Clinch River Nuclear Site  
NRC Docket No. 52-047

Subject: Submittal of Supplemental Information Associated with Hydrologic Engineering in Support of the Clinch River Nuclear Site Early Site Permit Application

Supplemental Information Regarding Site Safety Analysis Report Section 2.4,  
“Hydrologic Engineering”

Figure 2.4.1-5 Tennessee River System (Sheet 1 of 2)

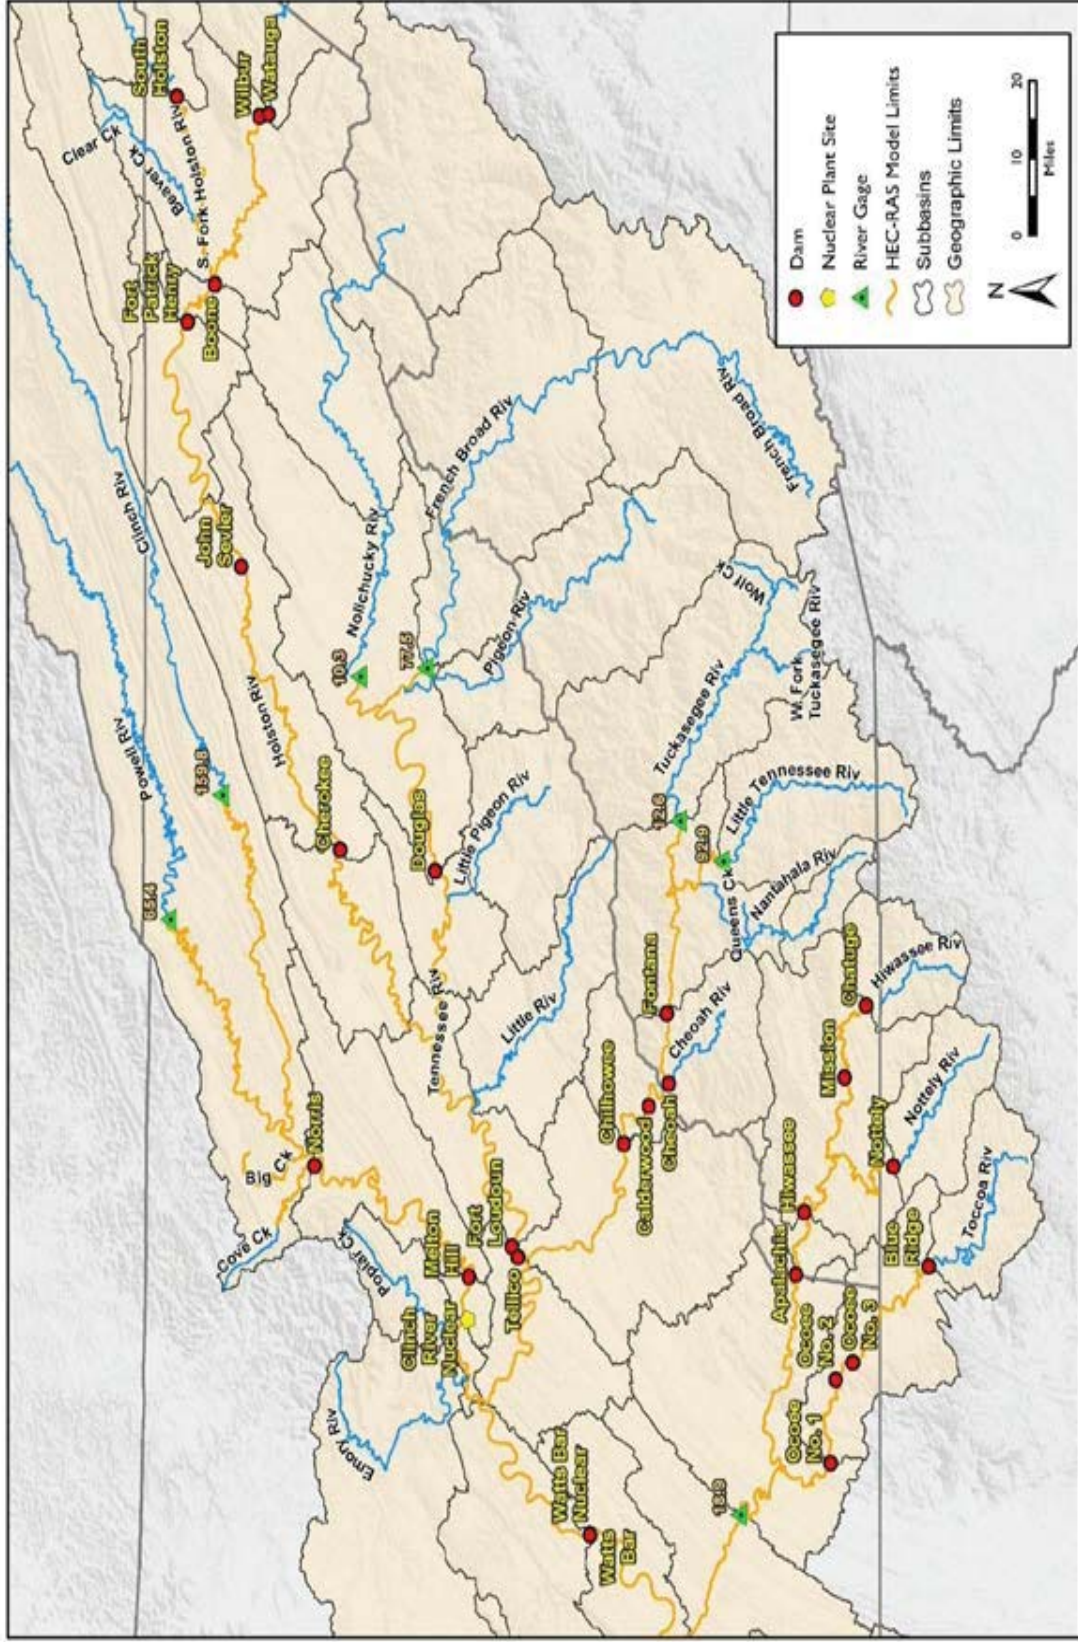
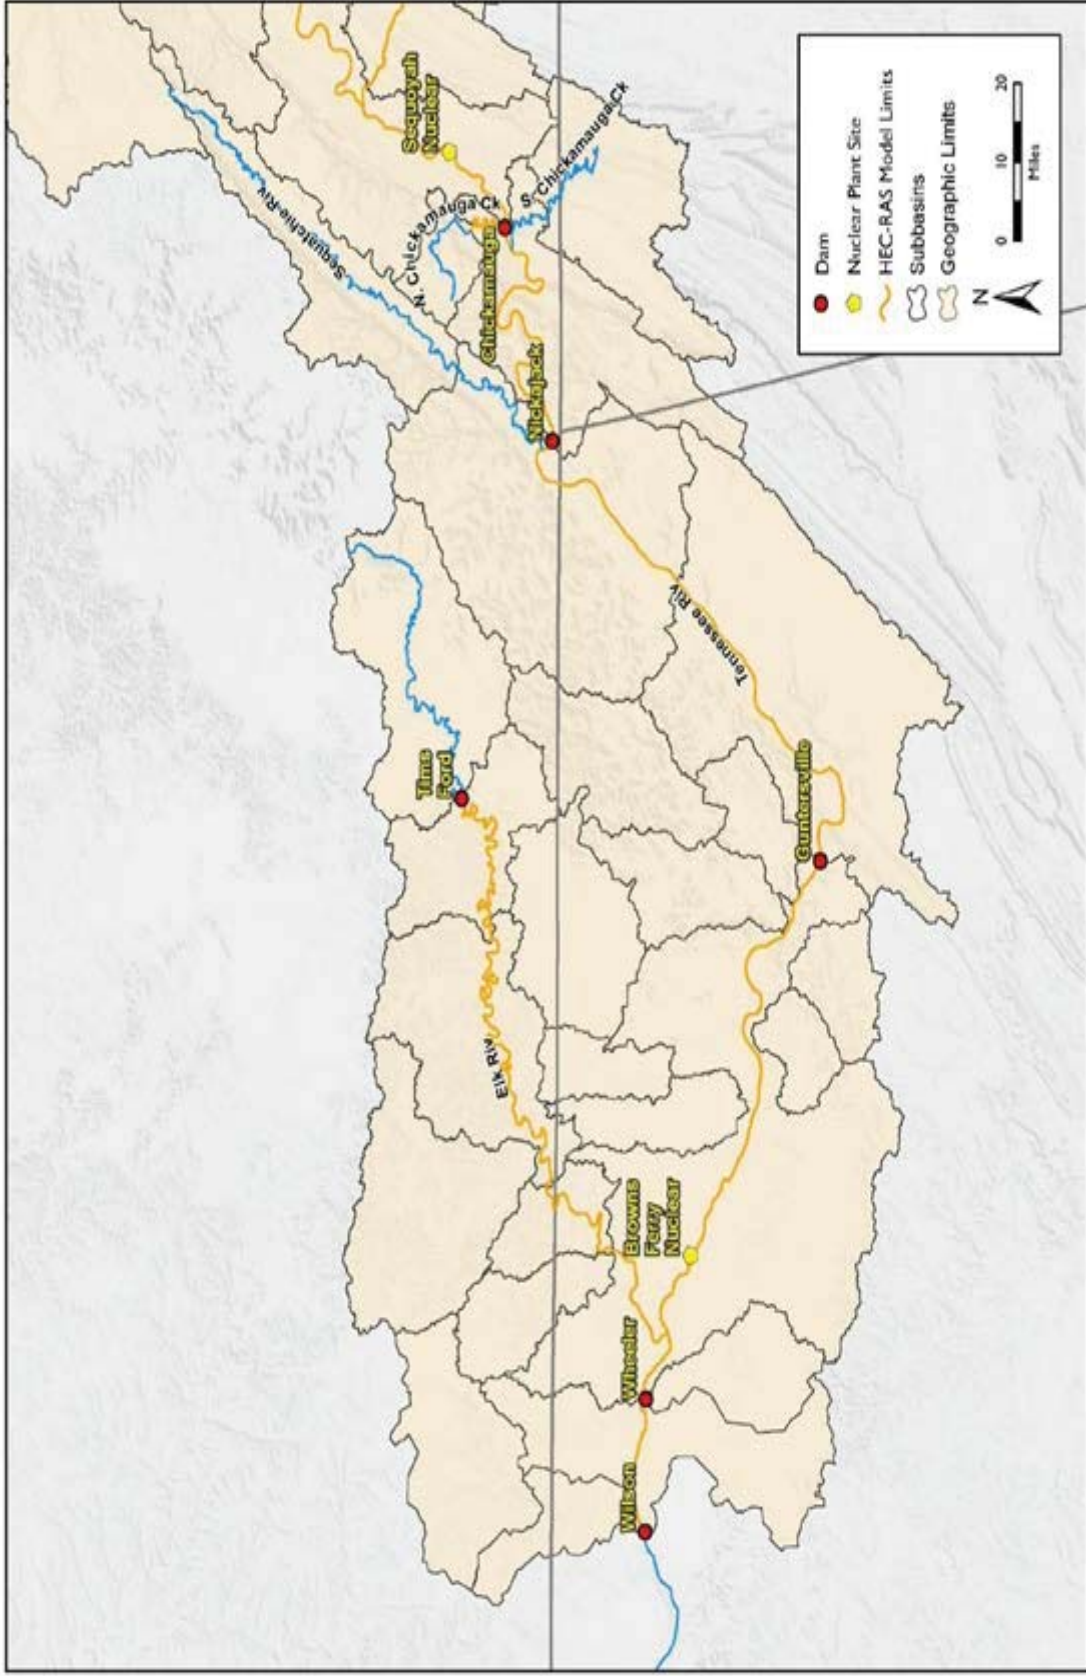
A GIS map showing the location of all dams upstream of Watts Bar Dam in relation to the layout of the Tennessee River and its tributaries is being added to the SSAR. Existing Figure 2.4.1-5 is being removed and replaced with new Figure 2.4.1-5, "Tennessee River System," Sheets 1 and 2 of 2. A copy of the new Figure 2.4.1-5, Sheets 1 and 2 of 2 is provided in Attachment 1.

Existing Figure 2.4.1-5 is being replaced with new Figure 2.4.1-5, Sheets 1 and 2 of 2

Figure 2.4.3-4. Flood Operational Guide –Norris Dam (Sheet 1 of 2)

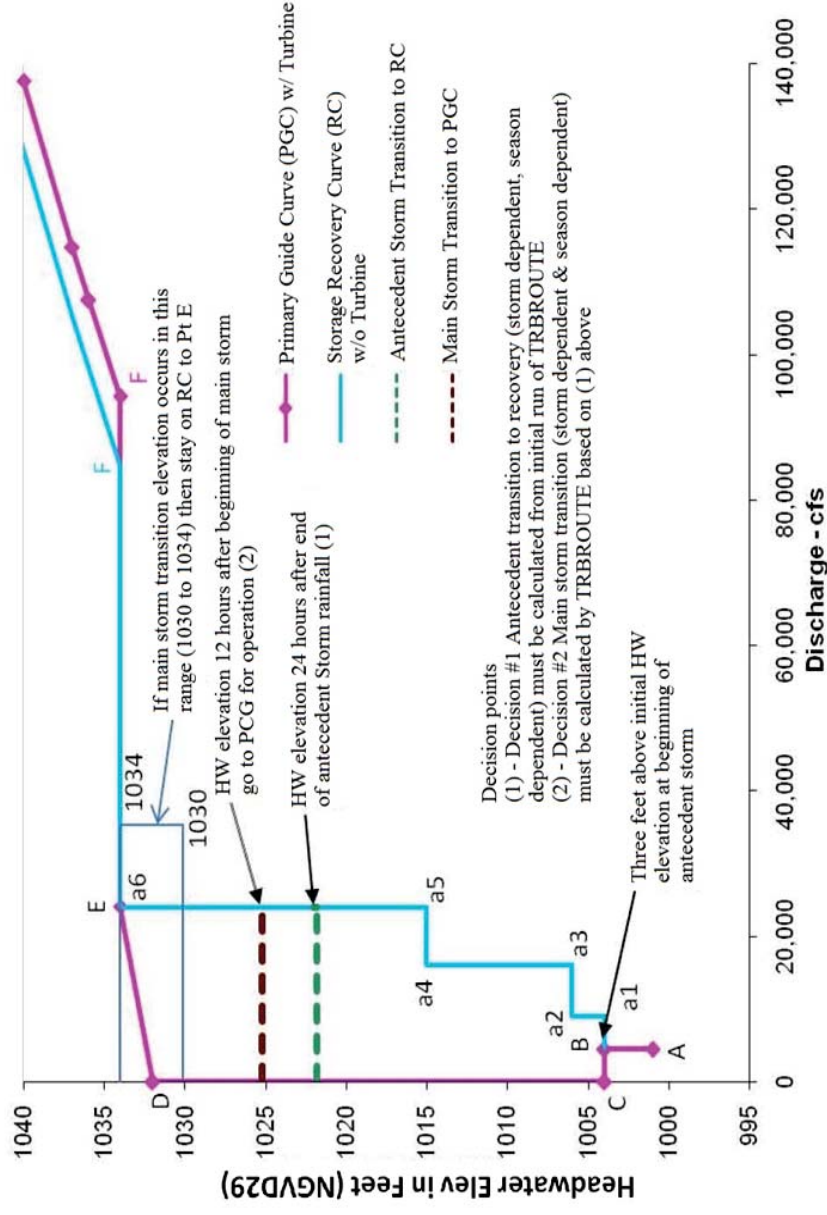
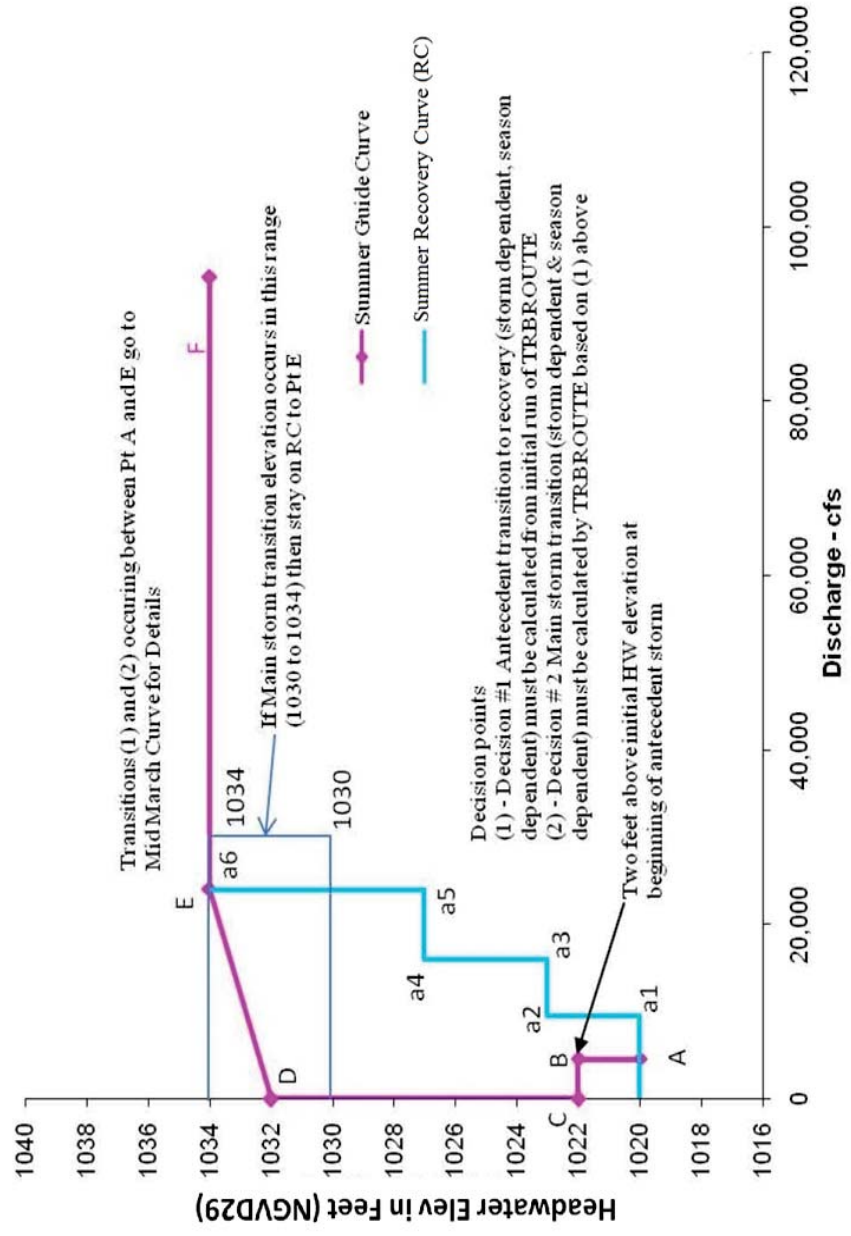
A discussion to provide the operational curve of the Norris Dam as well as the various cases presented in the rating curve figures and their application to the HEC-RAS simulations is being added to SSAR Subsection 2.4.3.4.4, "Design Storm Implementation." In addition, SSAR Figure 2.4.3-4, Sheets 1 and 2 are being revised and Figure 2.4.3-7, Sheet 2 of 2 is being removed. See the markup provided in SSAR Subsection 2.4.3.4.4, fourth and fifth paragraphs, and the last four sentences of this Subsection, revised Figure 2.4.3-4, Sheets 1 and 2, and Figure 2.4.3-7 is shown removed, in Attachment 3.

Figure 2.4.3-4 Sheets 1 and 2 are modified and replaced with new Figure 2.4.3-4 Sheets 1 and 2

Figure 2.4.3-4 demonstrates the current operational guide for mid-March at Norris Dam. At Point (Pt) A (starting point) on the curve, the turbine discharge is 4500 cfs and discharge is controlled by the spillway gates, turbine outflow, and sluices. As flood waters enter the reservoir and increase the headwater to 1005 feet, turbine operation ceases and sluices and spillway gates are closed (Pt B to C) (Figure 2.4.3-4). As flood waters continue to enter the reservoir with the discharge outlets closed, the reservoir elevation reaches 1032 feet (Pt D). At elevation 1032 feet, spillway gates begin to open and sluiceway operation is adjusted to allow an increasing discharge until the headwater elevation reaches 1034 feet (Pt E). At this elevation, gates continue to be raised to increase flow and sluices and turbines are adjusted to maintain 1034 feet headwater elevation (Pt F) until discharge points are at fully capacity and flow transitions to the dam rating curve. As additional flood waters enter the reservoir, the reservoir headwater elevation response is as indicated by Case 1 of the Norris Dam rating curve, Figure 2.4.3-7. As the flood waters recede, the operational guides follow the flood accession curve in reverse order to Pt E on Figure 2.4.3-4 at a discharge of 24,000 cfs. At this point, spillway gates and sluices are operated to decrease reservoir elevation until elevation 1015 feet

Figure 2.4.3-7. Dam Rating Curve – Norris Dam (Sheet 1 of 2)

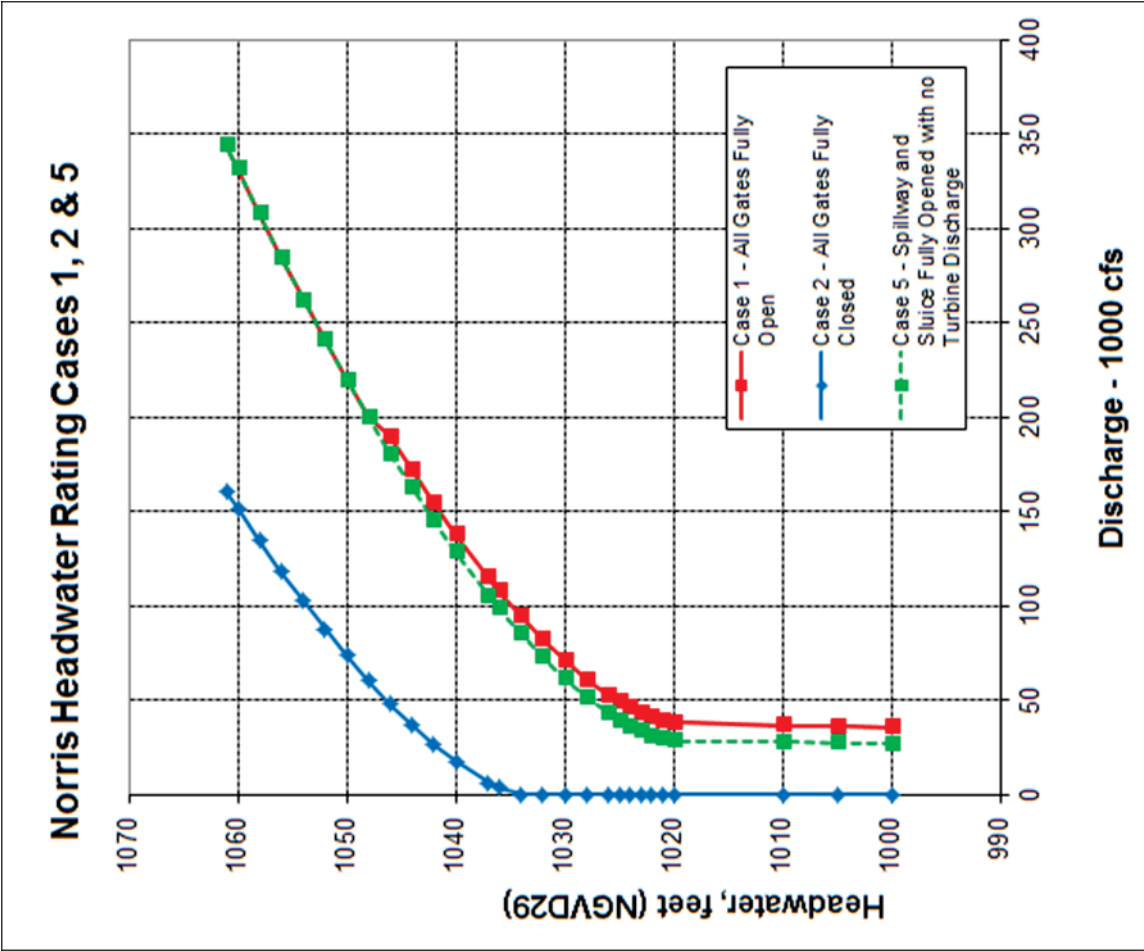
Figure 2.4.3-7. Sheet 2 of 2 is removed
